Your ref: CAS-259559-X8H3
Our ref: P2023/0861

RESPONSE TO CONSULTEE COMMENTS

On behalf of Marshalls Mono Limited (Marshalls) I write in response to the letter dated 15th August (reference: CAS-259559-X8H3) from Natural Resources Wales in relation to the planning application P2023/0861.

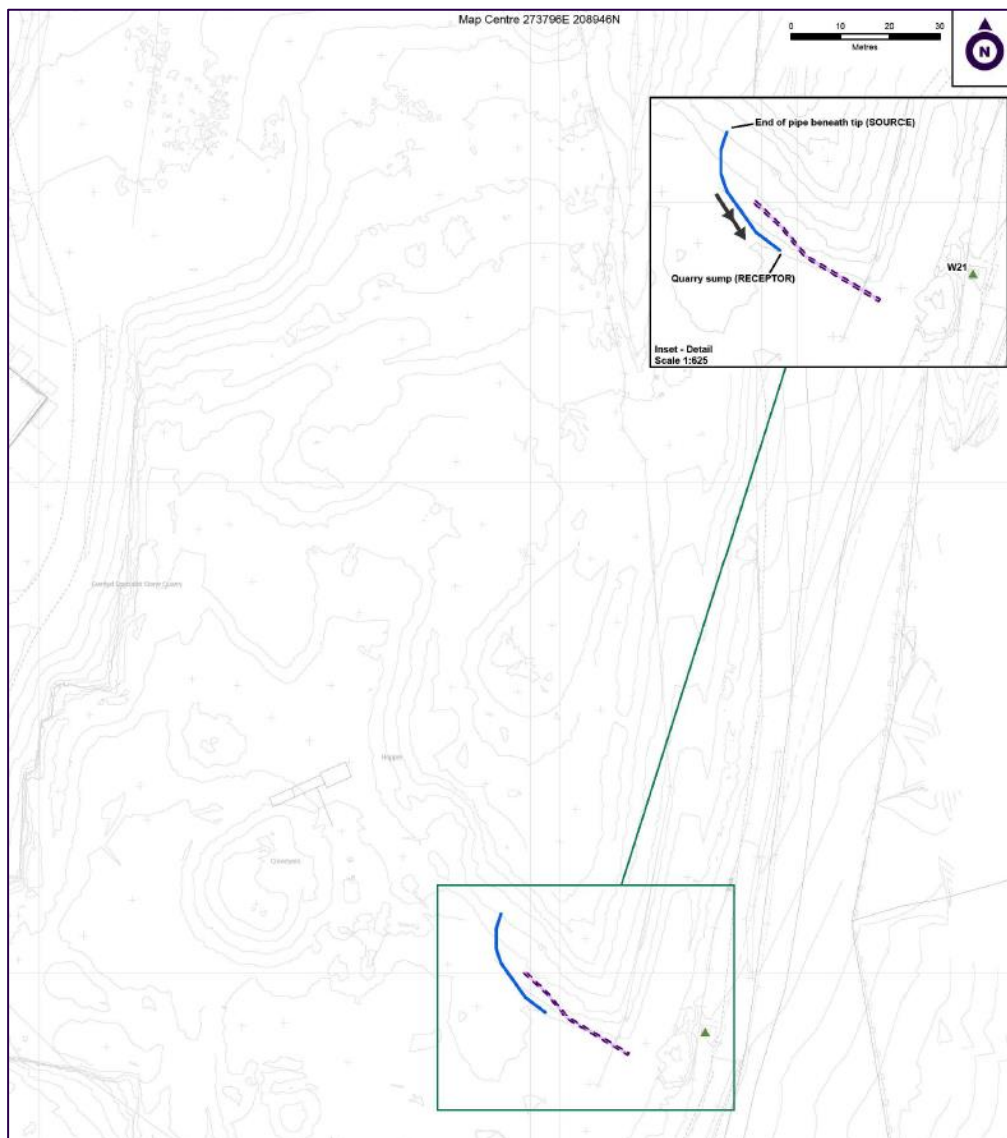
- *In view of their findings, does the operator need to augment or review any of the existing water management controls (Condition 34) and/or plans for the site? It would have been useful if W21 could have been plotted on the survey plan provided of the drainage pipe route, provided in the Marshalls document.*

However, purely for illustration purposes, the attached shows the path of the previously exposed pipe in purple (as submitted in the Method Statement – NB there is a “gap” between the current end of the pipe and the previous pipe pathway as this was beneath the tip at the date the pipe was surveyed, this section of tip has since been removed, hence the “gap”).

It also shows the directional flow of water in blue from the end of the pipe based on grid reference points noted during our recent inspection, which is currently still buried beneath the tip (source), the flow of water from the pipe (pathway) into the quarry sump (receptor). All of which is in accordance with the submitted surface water management plan.
